APPLICATION NO.	FILING DATE	FIRST NAMED INVENTOR	ATTORNEY DOCKET NO.	CONFIRMATION NO.
10/726,642	12/04/2003	Andreas Rinke	P24369	6203
7055	7590	01/13/2006	EXAMINER	
GREENBLUM & BERNSTEIN, P.L.C.			SHARMA, RASHMI K	
1950 ROLAND CLARKE PLACE			ART UNIT	
RESTON, VA 20191			PAPER NUMBER	
			3651	
DATE MAILED: 01/13/2006

Office Action Summary	Application No.	Applicant(s)	
	10/726,642	RINKE ET AL.	
	Examiner	Art Unit	
	Rashmi K. Sharma	3651

Application No. 10/726,642 Confirmation No. 6203
 Applicant: Andreas RINKE et al. Attorney Docket No. P24369
 Title: MULTIFUNCTIONAL CONVEYING DRUM
 Responsive to Official Communication dated: July 14, 2005
REPLACEMENT SHEET

FIG. 2

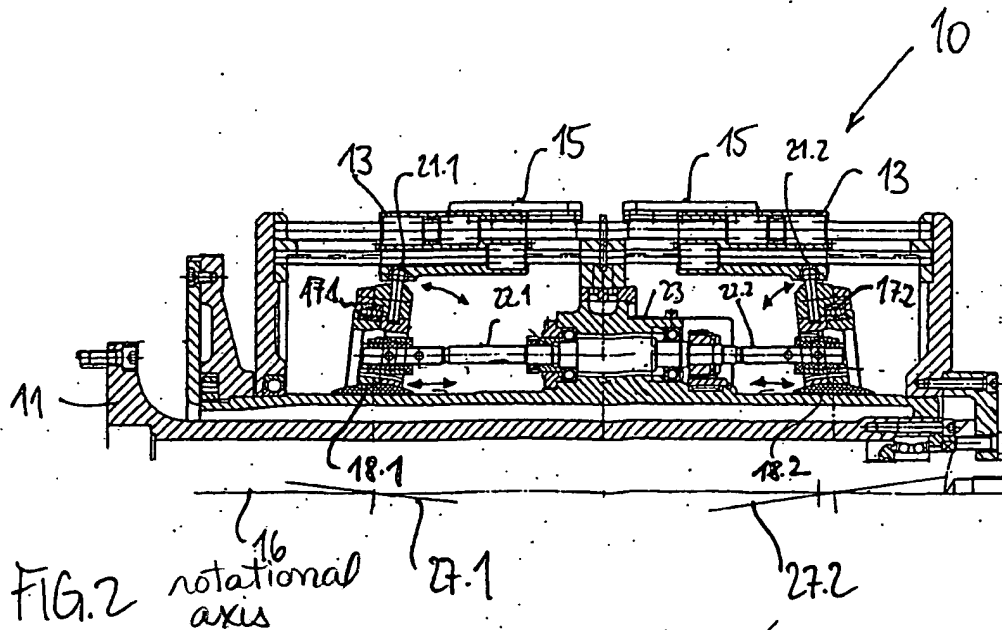
Regarding the drawing objections and the 112 second paragraph rejections, Applicant filed replacement sheets for Figures 2, 3 and 5, however it is still unclear as to how the wobble plates rotate about horizontal rotational axes 27.1 and 27.2. It appears as though the wobble plates are rotating about vertical axes, as indicated by the double arrows depicted in Figures 1 and 2. It is still unclear as to what structure rotates about 27.1 and 27.2 and exactly how the angle between axes 27.1 and 27.2 is changeable relative to axis 16. Further clarification is required.

Not Approved - RS

The replacement sheets of drawings attached as part of the Appendix includes changes to Figures 2, 3, and 5. These sheets, which include Figures 1 – 5, replace the original sheet including Figures 1 – 5. In Figures 2, 3, and 5, reference planes 27.1, 27.2 have been added for wobble plates 17.1, 17.2, respectively.
